City of Chandler Planning & Zoning Commission

THE CITY OF CHANDLER PLANNING & ZONING COMMISSION WILL MEET FOR A REGULAR SCHEDULED MEETING **TUESDAY, NOVEMBER 1, 2016**, IN THE CITY HALL OF CHANDLER, TEXAS AT **6:00 PM**

PROJECT: Gateway RV Park Site Plan revision and revision to operating rules

PROJECT: Main Street Market Site Plan Phase III Revision

The current approved floor plan

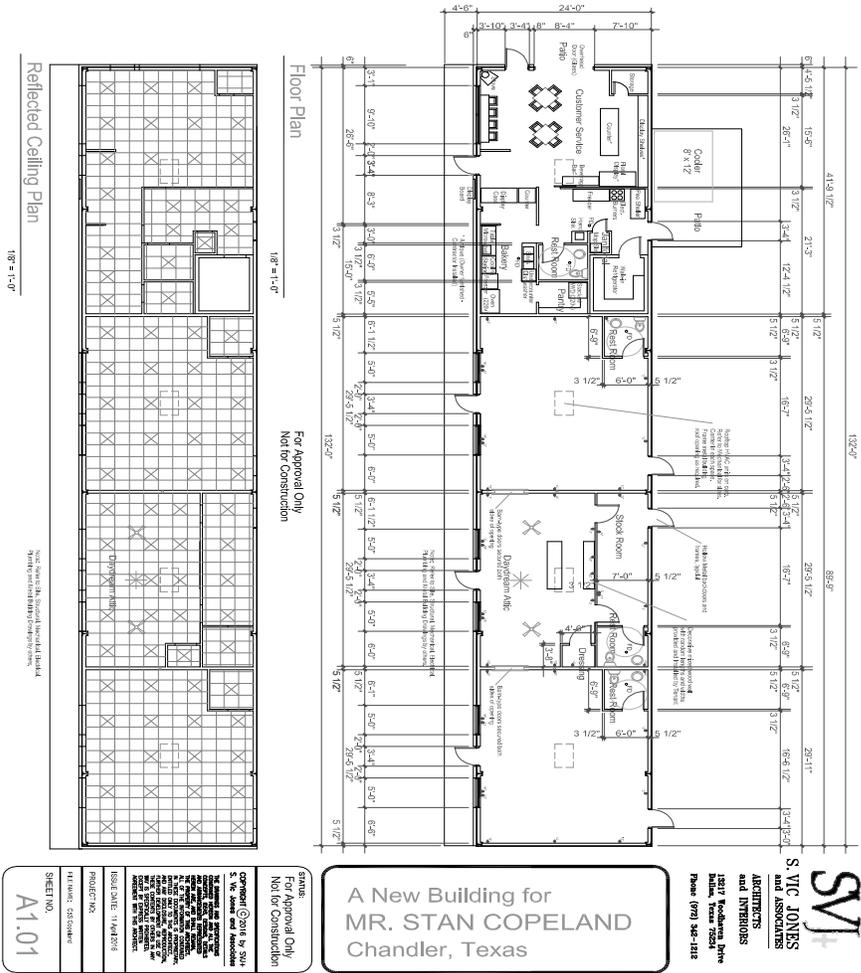
Our original plan, two years ago, had a BBQ restaurant on the west side of our building and a screened in porch approved as an appendage to the building making the footprint of the building approximately 132' x 24'. This plan was approved along with the site plan that had two handicapped parking spaces to the west of the porch. Keep in mind that the original parking plan took into account that we would have a restaurant and our parking spaces are more than adequate for the current retail shops. Potential tenants changed their minds on the restaurant and the new plans that were approved had four shops and basically the same footprint as the original drawings, but with no porch. Now we are requesting to extend the building with an appendage carport/covered drive.

The plans are attached that would have us build a nice complimentary carport/covered drive to the west of the west end shop. The materials used will be the same as those that were used on the new building, i.e. r-panel roof, paint grip metal siding (architectural metal) siding, and wood columns in brick footings. It should look very nice and compliment the buildings operation.
